## Publishing Hardware Manuals for the FX5UJ CPU Modules on the Web

FX5UJ CPU module

This technical bulletin informs you that hardware manuals for the MELSEC iQ-F series FX5UJ CPU modules will be published on the Web instead of bundling with modules.

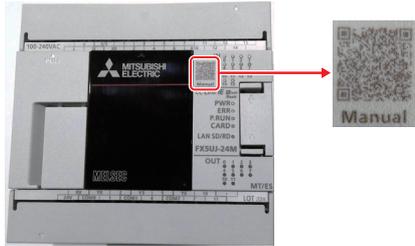
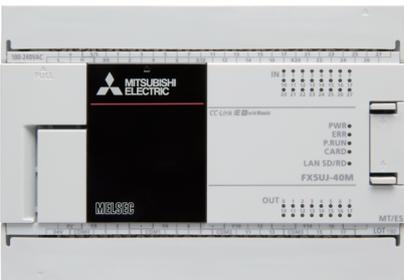
A leaflet, Safety Guidelines, will be bundled with the module instead of the hardware manual as follows. In addition, the two-dimensional code to browse the hardware manual will be added on the CPU module.

Item	Relevant model	Before change	After change
Bundled item	All models	■Japanese and English Hardware manual [IB(NA)-0800636]	■Japanese, English, and Chinese Safety Guidelines [IB(NA)-0800670]
Module	FX5UJ-24MR/ES FX5UJ-24MT/ES FX5UJ-24MT/ESS		The two-dimensional code will be added. 
	FX5UJ-40MR/ES FX5UJ-40MT/ES FX5UJ-40MT/ESS		The two-dimensional code will be added. 
	FX5UJ-60MR/ES FX5UJ-60MT/ES FX5UJ-60MT/ESS		The two-dimensional code will be added.
